# RENESAS TECHNICAL UPDATE

Product Category	MPU/MCU		Document No.	TN-SY*-A0086A/E	Rev.	1.00
Title	Note about the interruption during the transition to low power modes		Information Category	Technical Notification		
Applicable Product	S7G2, S5D9, S5D5, S5D3, S3A7, S3A6, S3A3, S3A1, S124, S128, S1JA Group	Lot No.	Reference Document	Refer table at the end of this document		
		All

Corrections are made to the figures and tables in the user's manual hardware as shown in 1 and 2 below.

#### 1) Figure 11.1 of S7G2, S5D9, S5D5, and S5D3 groups

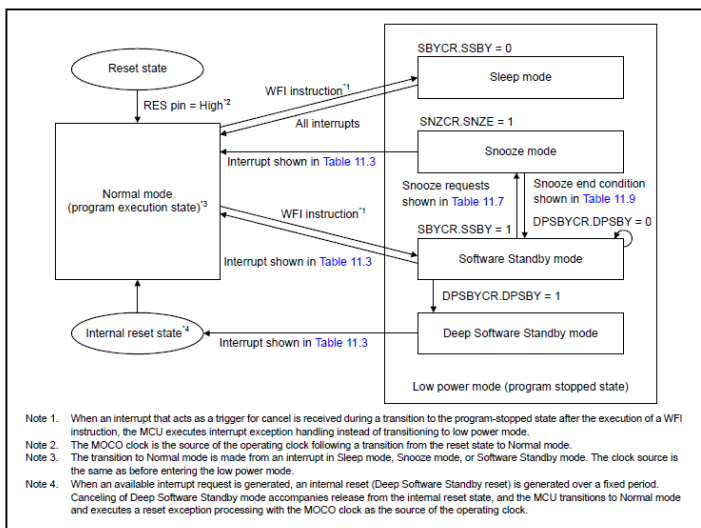
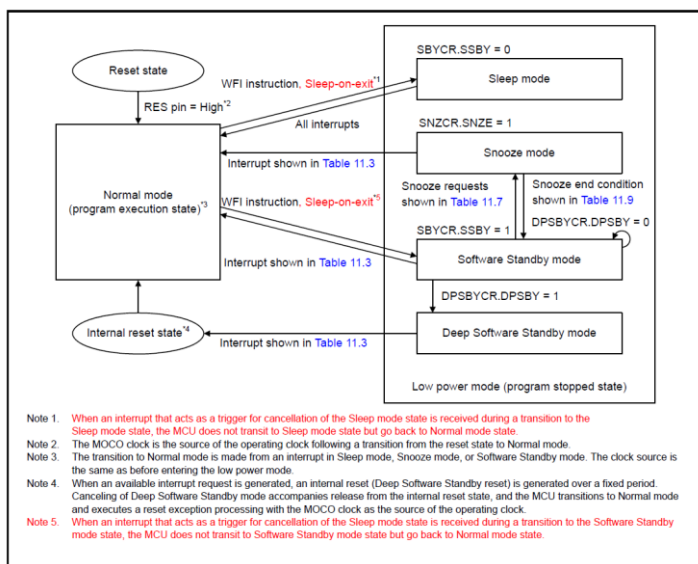
### 1. Correction of the Figure “Mode transitions”
